**RE: Defect Information Report – Supplemental Report No. 1
13V-074, FL-639A, SmartPlex Switch Hub Modules
Dealer Notice**

Subject: SmartPlex Switch Hub Module

Models Affected: Specific Freightliner 108SD, 114SD, and Business Class M2 vehicles manufactured December 3, 2011, through December 12, 2012.

April 2013
FL639A
NHTSA #13V-074
Transport Canada #13-088

Fig. 2, SHM Label Inspection

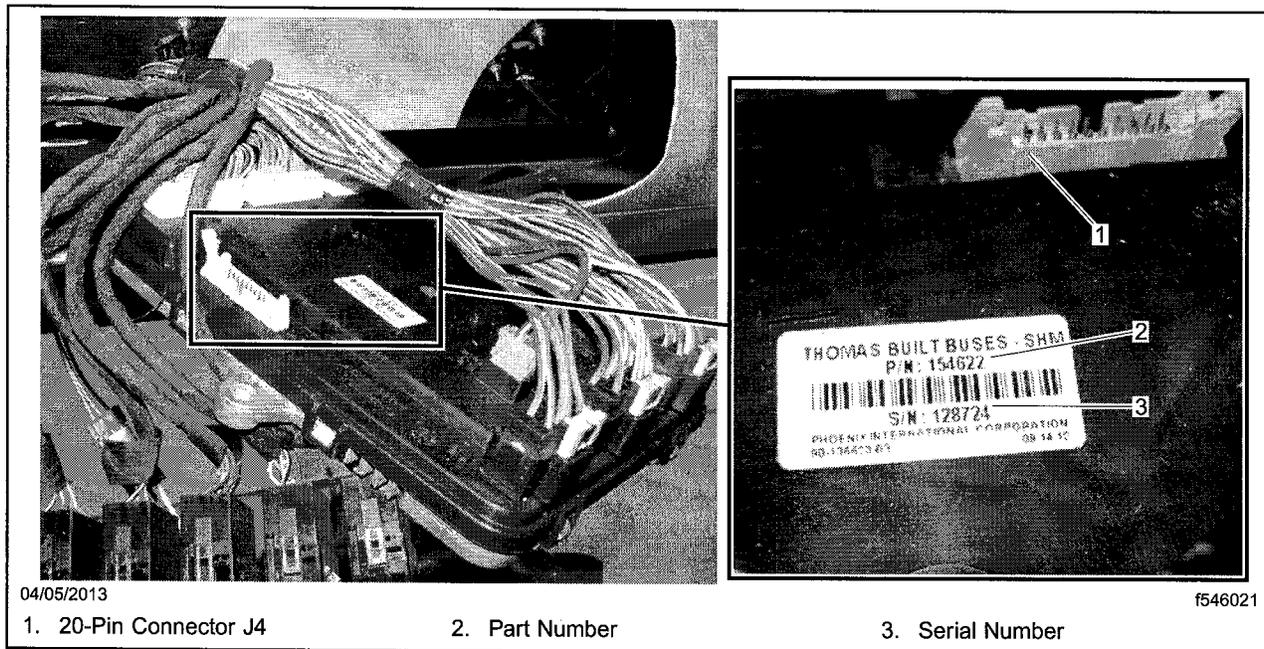
4. Gently lift the switch hub module from the mounting bracket, then remove it from the overhead console.
5. **Inspect the label on the back of the SHM for the serial number. See Fig. 2.**

If the serial number is 127176 or below, the SHM needs to be replaced. Proceed to the step 6.

If the serial number is 127177 or higher, the SHM does not need to be replaced. Proceed to the Important statement just after step 6.

Fig. 3, Harness Parts

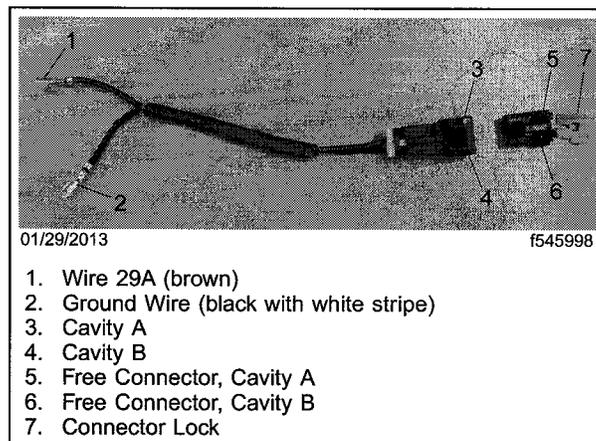
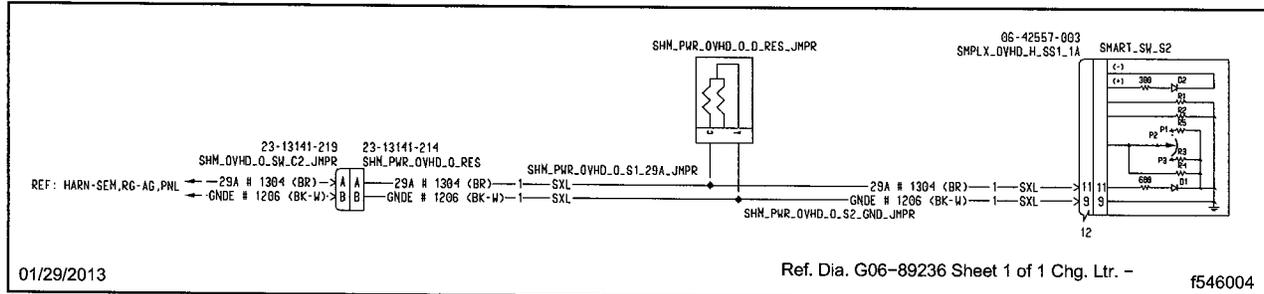
IMPORTANT: Check each switch for harness A06-60071-000. If this harness is already installed, replace it with the new harness (A06-89235-000) from the campaign kit. If harness A06-60071-000 is not already installed, install the new harness from the kit.

NOTE: Refer to Fig. 3 and Fig. 4 for a diagram of the resistive adapter harness provided for this procedure.
